# UNITED STATES PATENT AND TRADEMARK OFFICE

# Office Action Summary

10/812,426

CUTSHALL ET AL.

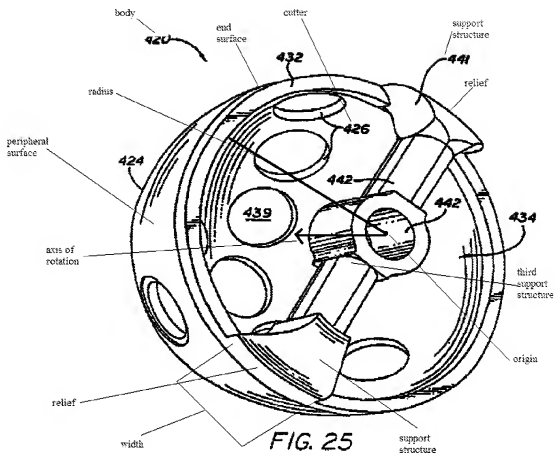
White discloses a reamer comprising a body 420 including a peripheral surface defined by a radius extending from an origin, said body defining an axis of rotation thereof, said body defining an end surface operably connected to peripheral surface and, said body defining a relief surface spaced from the axis of rotation and operably connected to the peripheral surface, wherein a peripheral surface is a hemisphere, with its edges defined by the end surface and the relief surface (see Figure 25 below); a cutter 426 operably associated with said body; a driver connector 442 coupled to the end surface (see fig. 26); and a support structure 441 secured to the relief surface of said body (see Figure 25 below and col. 10 lines 63-67 and col. 11 lines 1-15), the support surface being spaced from the driver connector (via 440- see fig. 26).

White teaches the claimed invention except for the peripheral surface being a truncated hemisphere.

It would have been an obvious matter of design choice to one skilled in the art at the time the invention was made to construct the peripheral surface of the body having the shape of a truncated hemisphere, in order to decrease the insertion profile. (In re Dailey and Eilers, 149 USPQ 47 (1966).).

The end surface of said body can be generally planar and perpendicular to the axis of rotation of said body; and the cutter and said body can be integral with each other (see Figure 25 below and col. 10 lines 63-67 and col. 11 lines 1-15). The body can also have a general form of a hollow, truncated hemisphere (see Figure 25 below and col. 10 lines 63-67), and the relief surface of said body can also be generally planar and parallel to the axis of rotation (see Figure 25 below). The body can also define a second relief surface spaced from the first mentioned relief surface (see Figure 25 below) wherein the second relief surface can define a width dimension therebetween, the width dimension being substantially smaller than twice the radius of said body (see Figure 25 below). The reamer can also further comprise second and third support structures secured to the second relief surface and secured to both first and second support structures for interconnecting said support structures, respectively. Both first and second support structures are spaced from the driver connector (via 440, see fig. 26). The reamer can also further comprise a driver (see col. 11 lines 7-15). The support structure can also be integral with said body (see col. 1 lines 13-15), and can also comprise one of a rib, a gusset, a bar, a tube, and a plate (see Figure 25 below and col. 11 lines 13-15). The support structure extends substantially along the relief surface of said body (see Figure 25 below). White further discloses a method comprising providing
